MIL-R-63997B(AR)
AMENDMENT 4
31 July 1993
SUPERSEDING
AMENDMENT 3
25 March 1992

MILITARY SPECIFICATION

RIFLE, 5.56MM: M16A2

FIGURE I. Targeting and accuracy diagram.

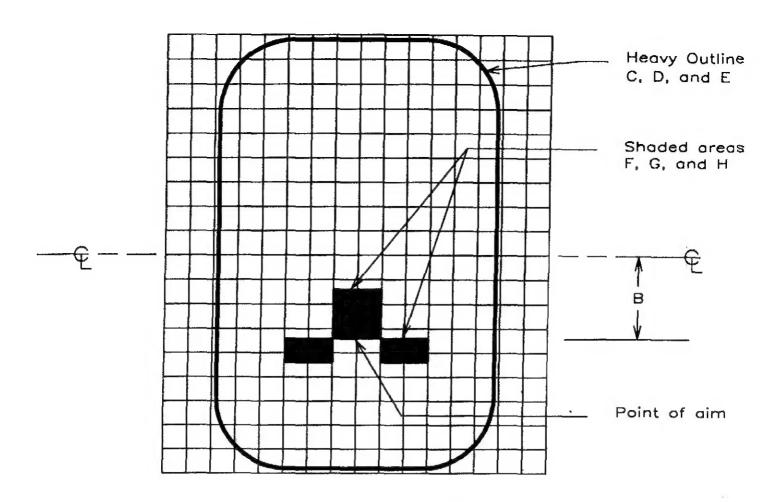
- * 3.4.6: Delete in it's entirety and substitute the following:
 - "3.4.6 Targeting and accuracy. A series of 10 rounds fired from each rifle at a range of 91.4 meters shall be within the extreme spread and targeting area (heavy outline) specified in Figure I when the front and rear sights are set as follows. The normal rear sight peep (sight rotated fully rearward) shall be used with the rear sight set centrally in the slot for windage within plus or minus five (5) clicks. The top edge of the front sight post flange shall be set flush to .030 inch below the bottom surface of the front sight slot. Ammunition shall be Government standard M855, 5.56mm ball cartridges conforming to Drawing 9342868 and shall have a vertical and horizontal standard deviation at 600 yards between 3.4 inches and 4.0 inches when measured in accordance with MIL-C-63989."
